**GOVERNMENT OF THE DISTRICT OF COLUMBIA**  
**DEPARTMENT OF TRANSPORTATION**

**MEMORANDUM**

**DATE:** September 14, 2018

**SUBJECT:** BZA Case No. 19751 – 2619-2623 Wisconsin Avenue NW

Figure 1 – Parking Restrictions (Source: Technical Memorandum prepared by Gorove/Slade, dated May 2, 2018)

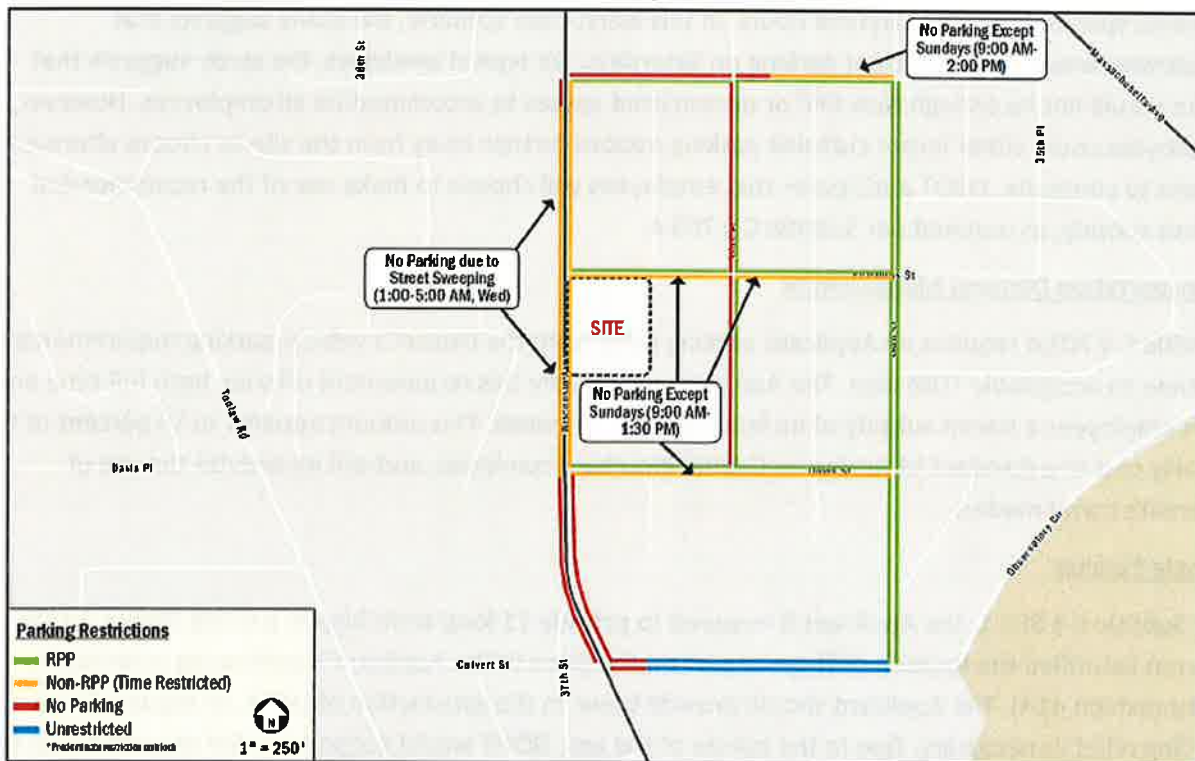
- The Residential Parking Permit (RPP) Streets nearby the project (see Figure 1) restrict parking to two (2) hours for vehicles for vehicles that do not display a Zone 3 permit. Employees would not be able to park on these streets for the entirety of a shift without being subject to enforcement.

As illustrated in Figure 1, the majority of streets within the vicinity of the project are Residential Parking Permit streets, which limit parking for vehicles to two (2) hours between 7:00 AM and 8:30 PM, Monday through Friday, for vehicles that do not display zone 3 permits. The time-restricted streets internal to the residential street network limit parking to Sundays, between 9:00 AM and 1:30 PM. On Wisconsin, vehicle parking is time-restricted along the northbound curb between 4:00 PM and 6:30 PM on weekdays to provide additional capacity for rush hour traffic. On the southbound side of Wisconsin, parking is restricted on Wednesdays between 1:00 AM and 5:00 AM for street cleaning purposes.
